Technical Service Bulletin: TSB200004

New Idler Pulley and Secondary Tensioner with Dust Seals

- QSX15 CM570 (Excavator and driller application **only**)

Figure 1, Drive Layout

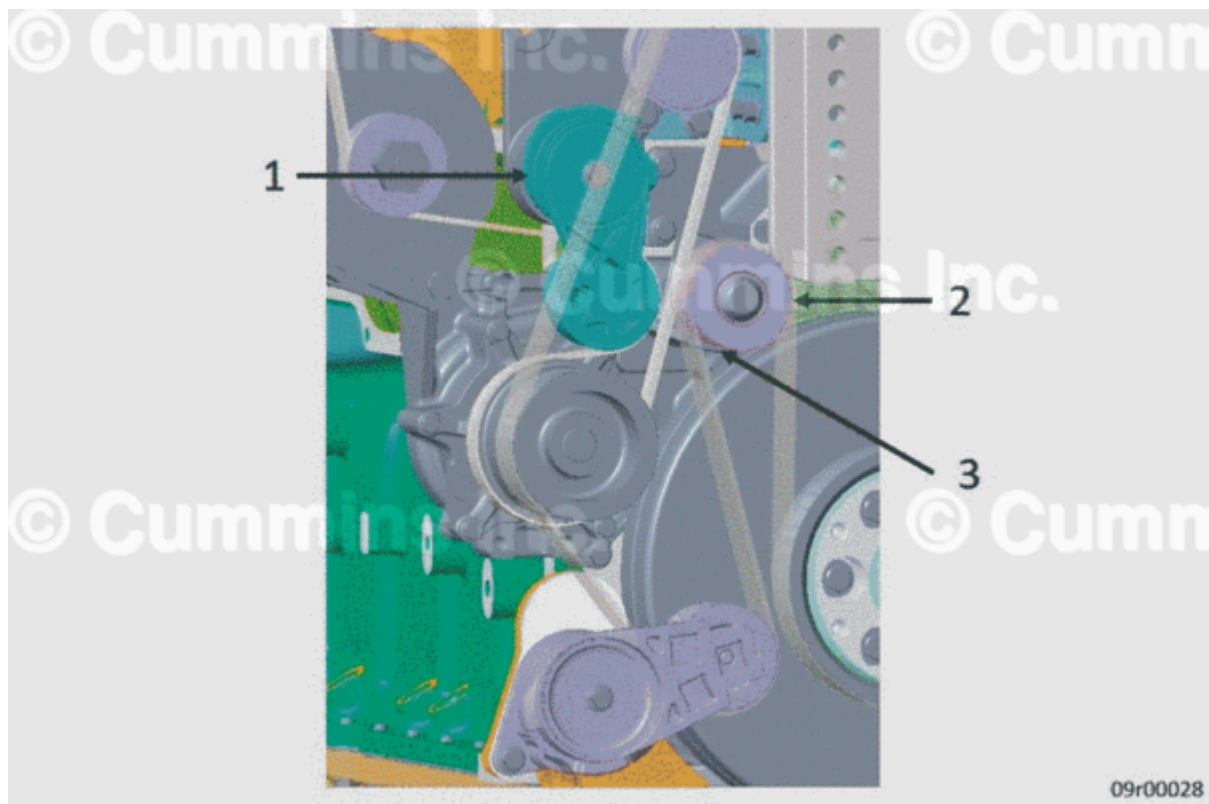
1. Remove primary drive belt (Drive Belt, Water Pump). Refer to Procedure 008-003 (</qs3/pubsys2/xml/en/procedures/10/10-008-003.html>).
2. Remove secondary drive belt (Drive Belt, Refrigerant Compressor). Refer to Procedure 009-052 (</qs3/pubsys2/xml/en/procedures/10/10-009-052-tr.html>).
3. Remove primary idler pulley, part number 3681587, and pilot adapter, part number 3681715. See Figures 1 and 2. Refer to Procedure 008-062 (</qs3/pubsys2/xml/en/procedures/10/10-008-062-tr.html>).

4. Remove secondary tensioner, part number 3104027. See Figure 1. Refer to Procedure 009-053 (/qs3/pubsys2/xml/en/procedures/10/10-009-053-tr.html).
5. Install new pilot adapter, part number 5582573, and new idler pulley assembly, part number 5582393. Refer to Procedure 008-062 (/qs3/pubsys2/xml/en/procedures/10/10-008-062-tr.html).

A new primary idler pulley and secondary tensioner, both with improved bearing dust seals, have been released.

7. Intall new secondary tensioner, part number 5582391. Use capscrew part number 3896408. Refer to Procedure 009-053 (/qs3/pubsys2/xml/en/procedures/10/10-009-053-tr.html).
